IFB #2018-100 **Explore Park Cabin Campground Infrastructure and Bathhouse**

ADDENDUM NO. 3

Balzer and Associates, Inc. Notice of Addendum #1: Drawing Clarifications

NOTICE OF ADDENDUM #1

PRELIMINARY YURT FLOOR PLAN

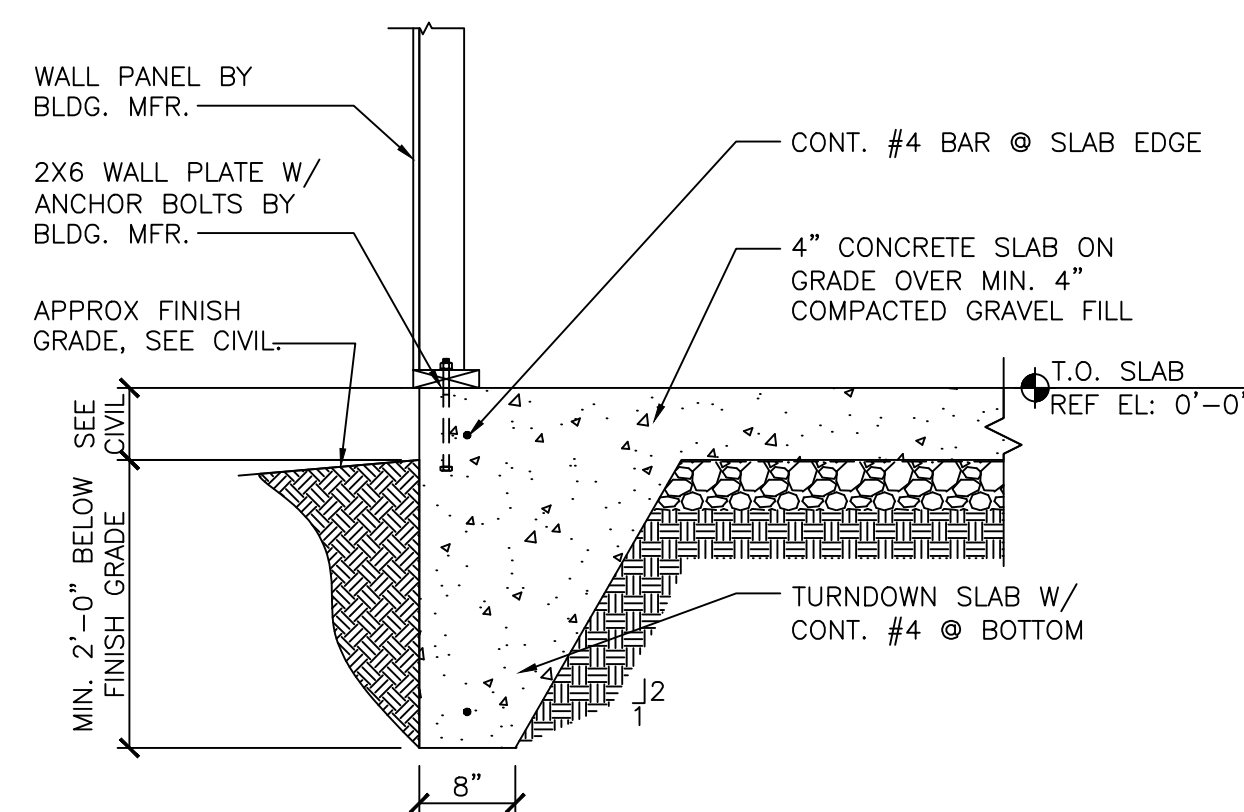
7. Sheet C10: Please see revised sheet C10. Notes regarding utility rough-in's/connections for the yurts were inadvertently left off of the yurt floor plan detail. Bidders shall include the extension of

water, sewer, and electric into yurts and stub ups for utility rough-in so that the yurts are tied into the site utilities.

1. FLOOR PLAN SHOWN IS PRELIMINARY FOR BIDDING PURPOSES ONLY. G.C. SHALL COORDINATE THE FINAL LAYOUT WITH THE CAMPGROUND OPERATOR PRIOR TO CONSTRUCTION.
2. FLOOR PLAN IS SHOWN FOR INFORMATIONAL PURPOSES ONLY. G.C. TO PROVIDE CONCRETE FOUNDATION ONLY. CAMPGROUND OPERATOR TO PROVIDE ACTUAL YURT CONSTRUCTION.
3. G.C. SHALL BE RESPONSIBLE FOR OBTAINING ALL REQUIRED PERMITS FOR CONSTRUCTION.
4. ORIENTATION OF YURT MAY BE DIFFERENT ONSITE, G.C. TO COORDINATE EXACT LOCATIONS OF WHERE UTILITIES NEED TO STUB OUT OF BUILDING WITH THE CAMPGROUND OPERATOR

YURT FOUNDATION OPTIONS

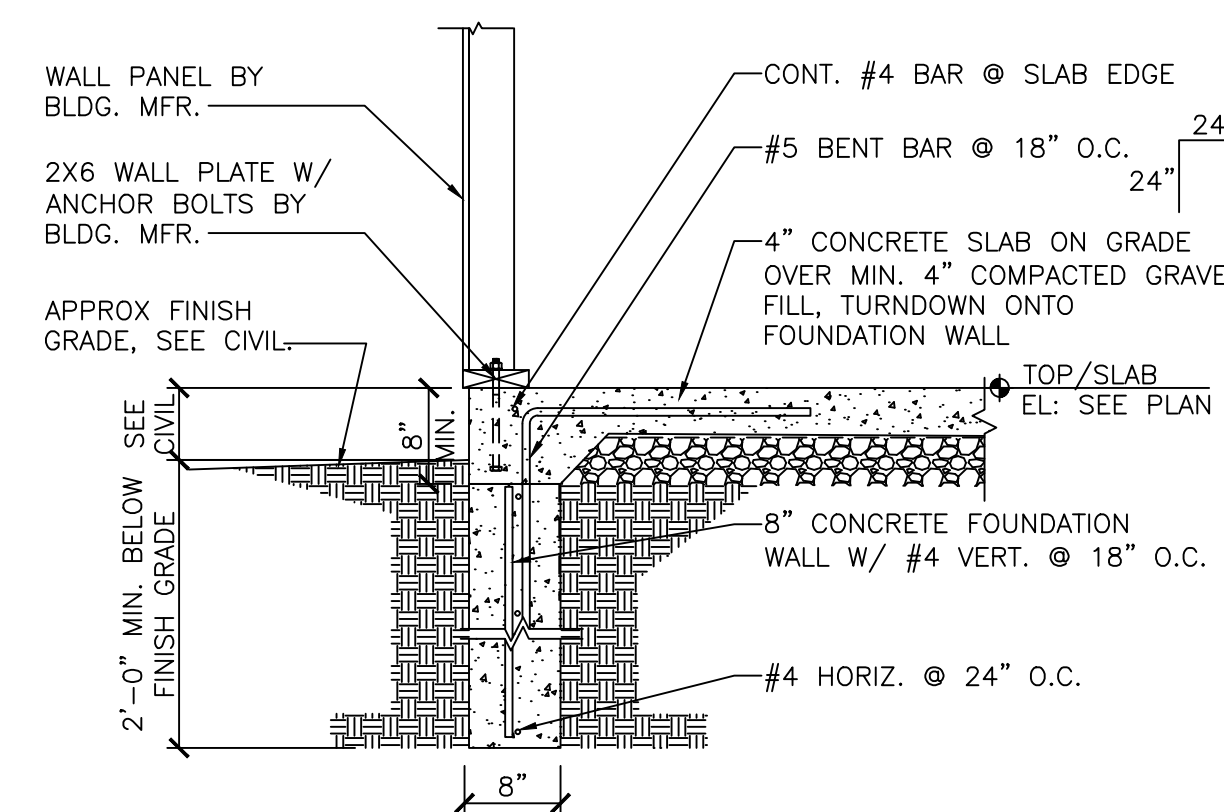
Please see Attachment B: Yurt Concrete Foundation Details, for further specification regarding the yurt foundations.
